REMARKS/ARGUMENTS

Amendments to the Drawings:

Serial No.: 10/712,327 **Title:**
Elec. Motor Driven Hand Held Tool
Inventor: Daniel Craven, et al.
Docket No.: P-US-PR 1091
~~Replacement Sheet~~ 2 of 2
Annotated

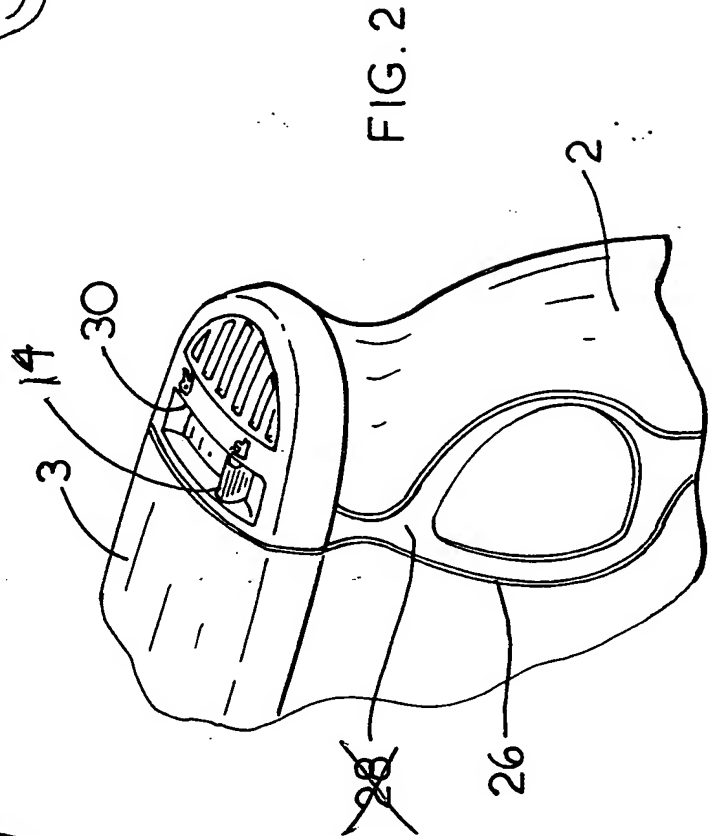
- the drawing quality has been improved to conform to US practice;
- Fig. 1 has been labeled as "Prior Art";
- in Fig. 2, reference number 28 has been deleted;
- in Fig. 2, reference number 14 has been added; and
- in Fig. 4, reference number 26a has been substituted for reference number 15.

FIG. 4

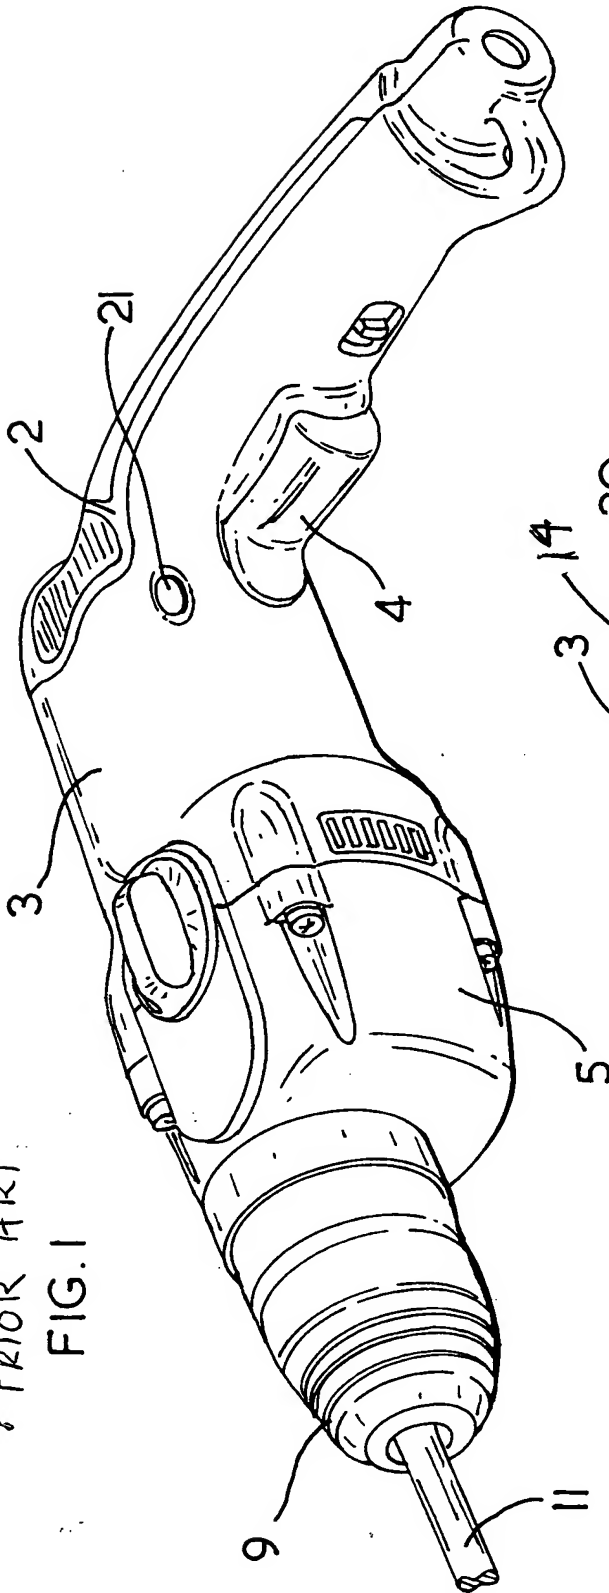
Replacement drawing conforming to US practice are submitted and Figure 1 has been labeled as prior art. Furthermore, during preparation of this Amendment, it was noted that the Specification and Drawings use reference number (15) to refer to both the motor and the "rearward edge of the upper portion of the motor housing." Therefore, Figure 4 is amended to use reference number (26a) to refer to the rearward "rim" of the upper portion of motor housing (3). The addition of reference number (14) and deletion of reference number (28) from Fig. 2 is purely editorial.
